NIRB File No.: 11MN034

Phase 1 All-Weather Access Road

**Agnico-Eagle Mines Limited
Responses to Information Requests**

11 December 2011

File:	AEM GIS Database	Figure	1

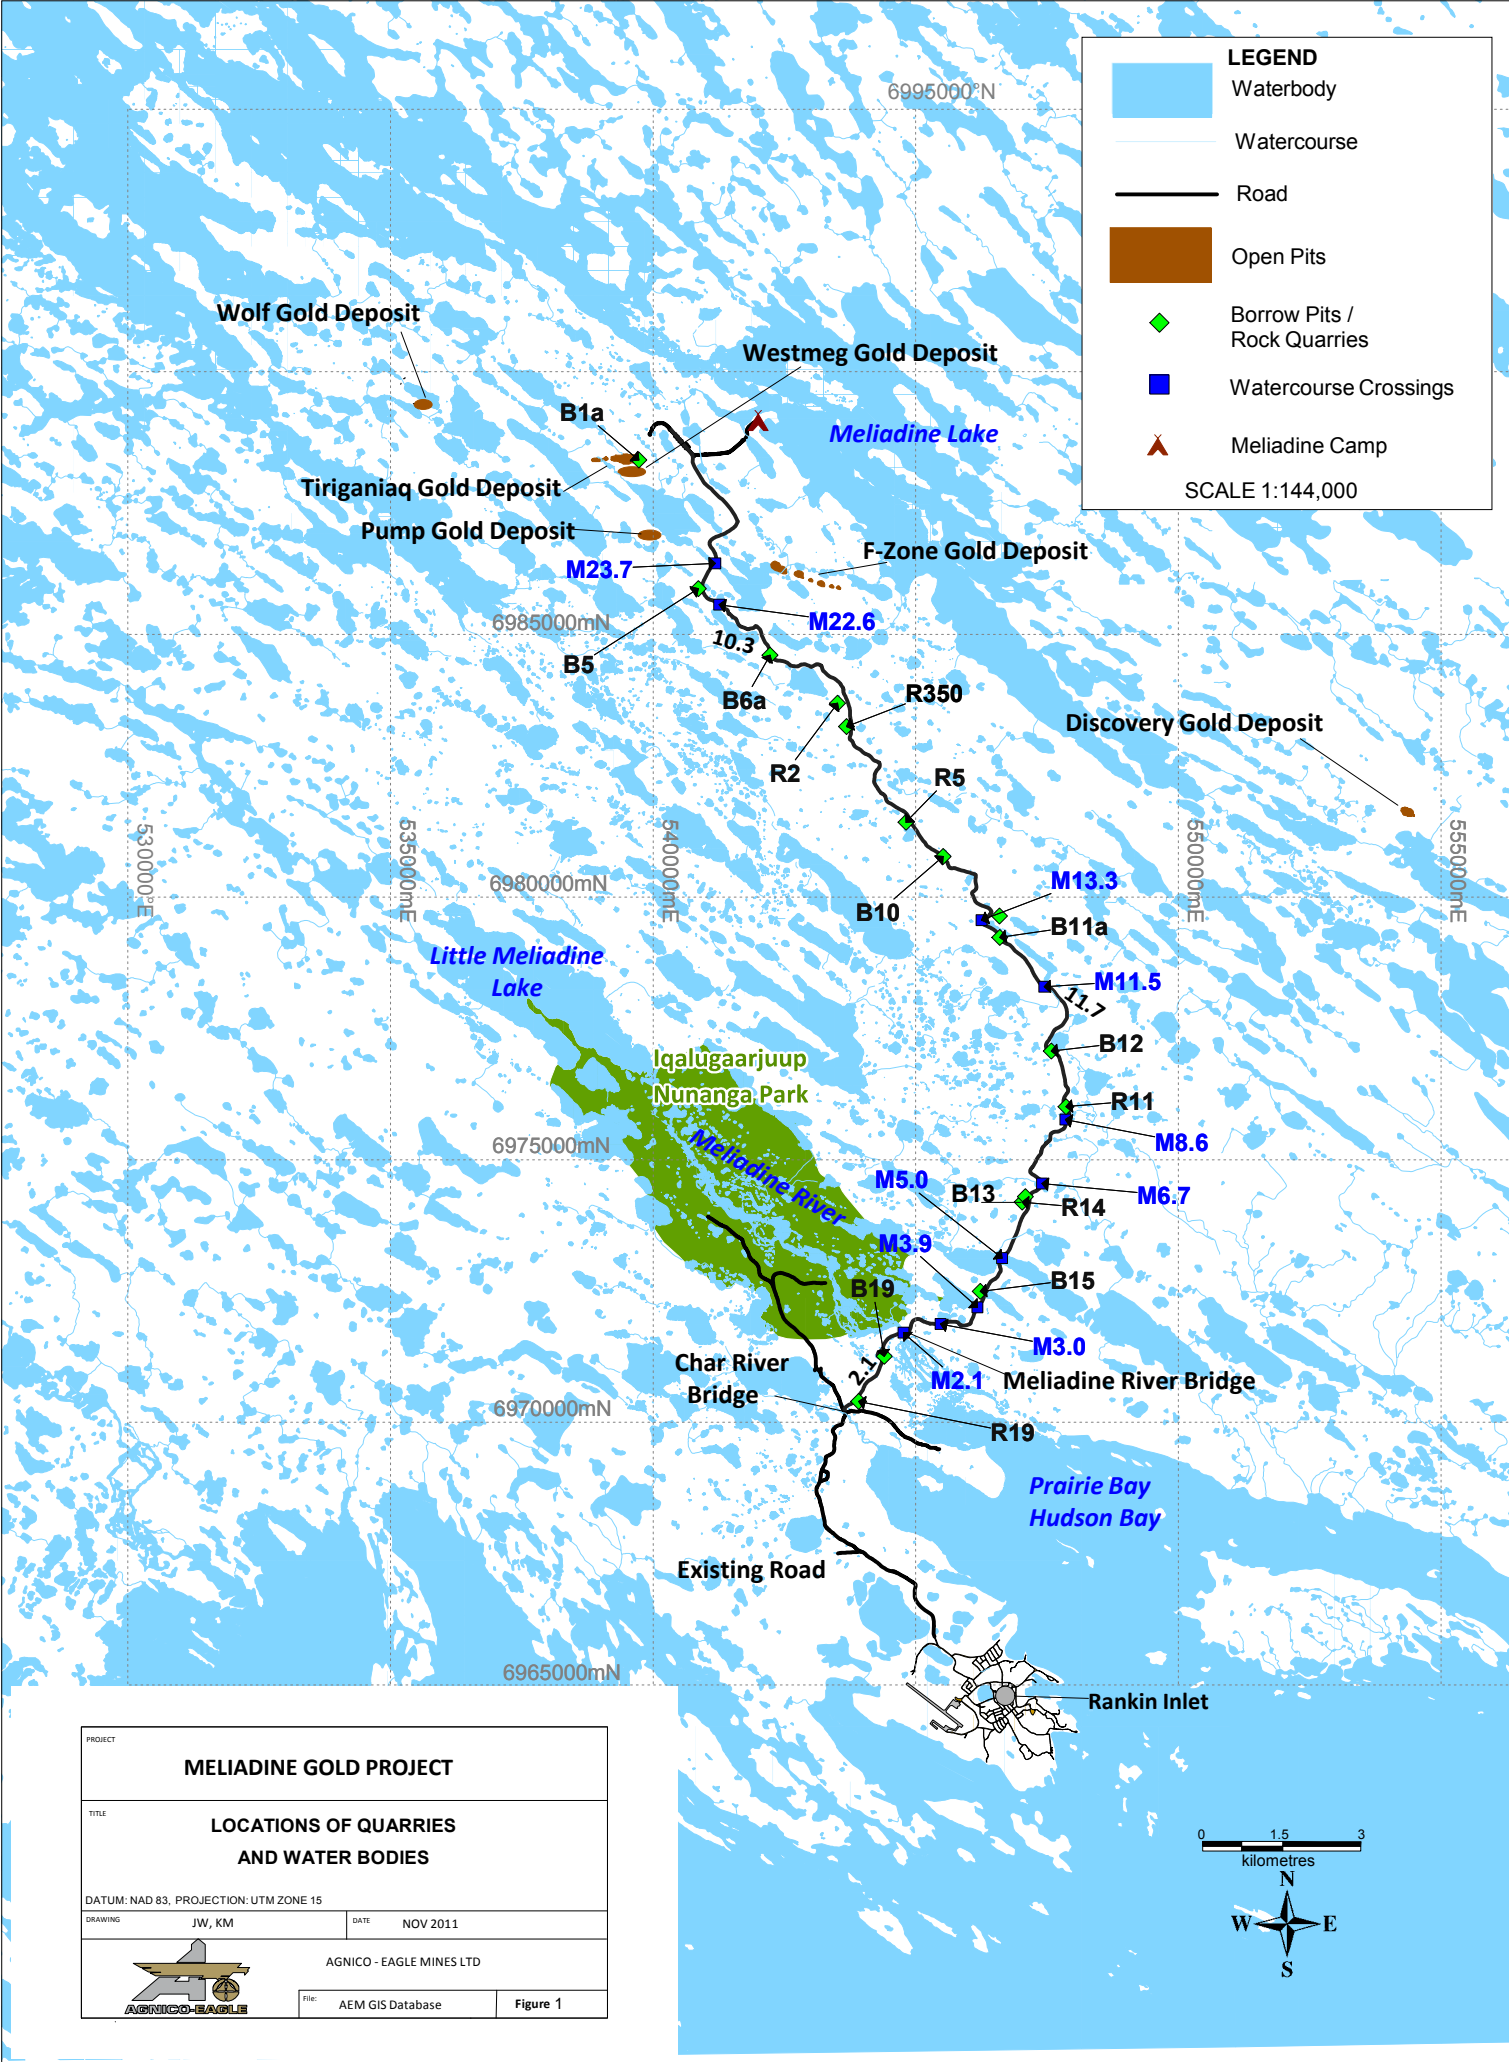
EC noted that p.28 of the Transportation Management Plan indicates only three crossings will be monitored following road construction (i.e. M3.0, M5.0, M23.6) as opposed to 4 noted on p. 120 of the EA. EC seeks clarification on how many crossings AEM plans to monitor and recommends the Plan be revised to reflect the location and number of crossings to be monitored.

AEM commits to sampling all eleven water crossings including the Char and Meliadine Rivers in the first open water season following road construction. The details are presented in the Monitoring Plan for the AWAR following Information Response #8. This Plan covers water quality, wildlife, road fill testing, permafrost, and hydrology monitoring.

N:\Bur-G-raphical\Projects\2007\1373\07-1373-0055\Vegetation\figure-04-01_sample-plots-vegetation.mxd

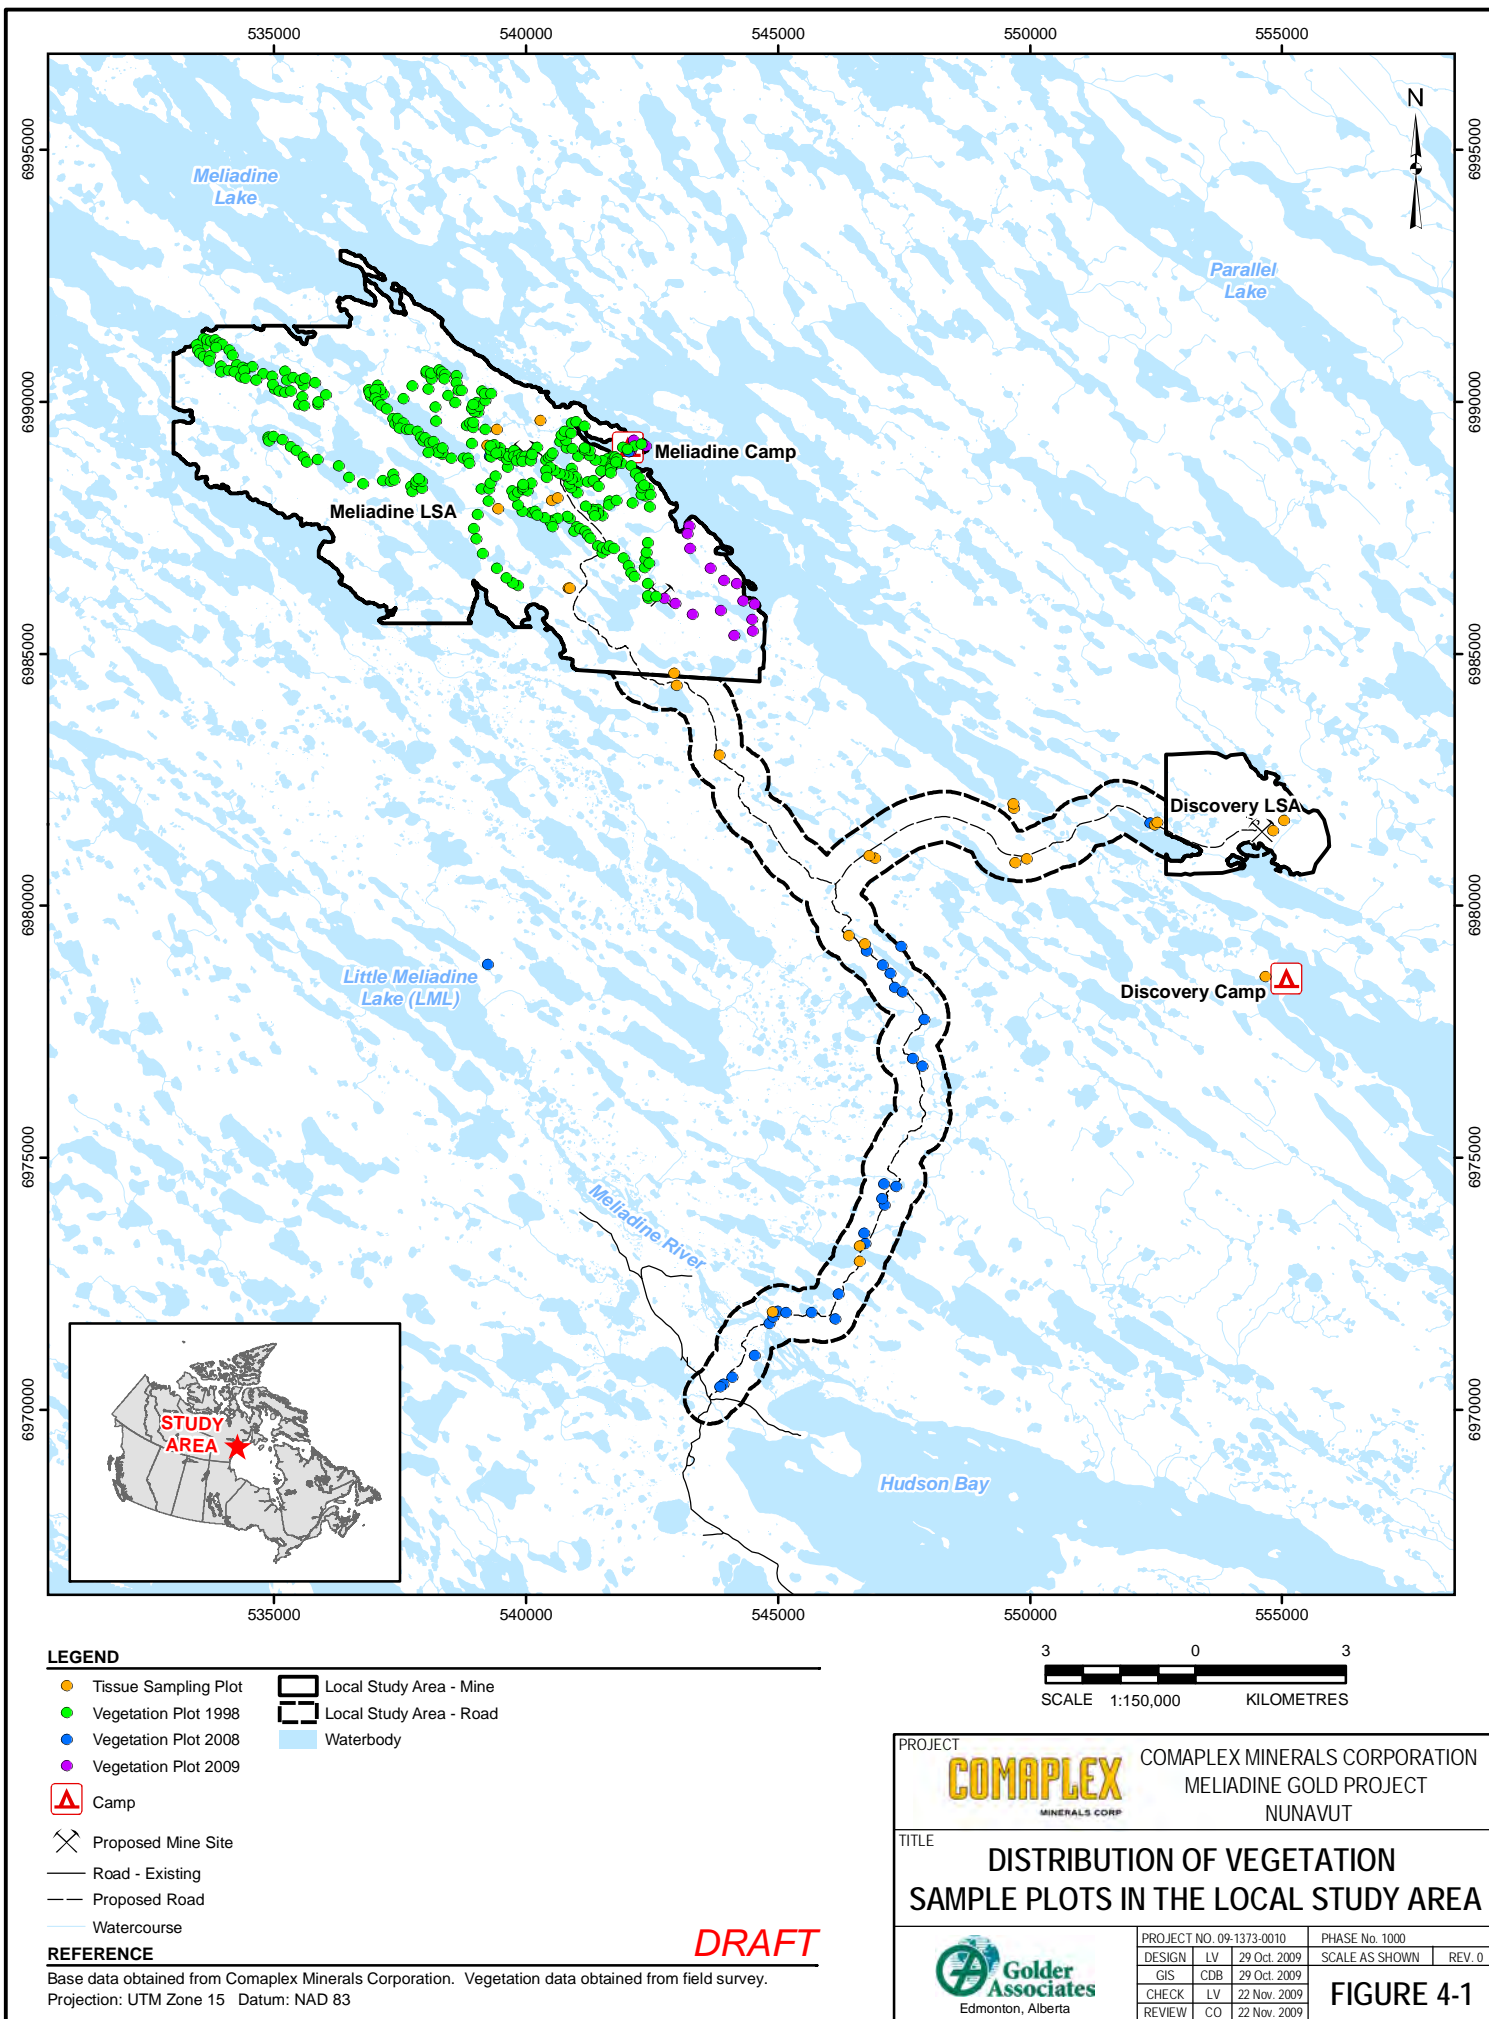
In the effects assessment for vegetation it is stated that no impacts to listed species (species listed under SARA or CESSC) are expected as none were identified in the project footprint. The report does not provide evidence backing this statement as it is not clear where the vegetation survey took place in context of the project footprint. More detail regarding the vegetation survey methods and a location map should be provided.

Field survey methods followed previously established protocols that were developed for the Diavik Project (Burt 1997) and other projects, including the Meadowbank Gold Project and the Baffinland Iron Mines Mary River Project (unpublished data). Prior to undertaking the vegetation surveys, preliminary plot locations were identified through a review of 1:50 000 topographical and 1:10 000 airphotos. Vegetation plots were established in a representative location within a given plant association type, and care was taken to avoid transitional areas. A 5x5 m plot size was used to collect vegetation data, including plant species and percent cover information, and a Global Positioning System (GPS) coordinate was taken at the centre of each plot. Information collected at each plot included the following variables:
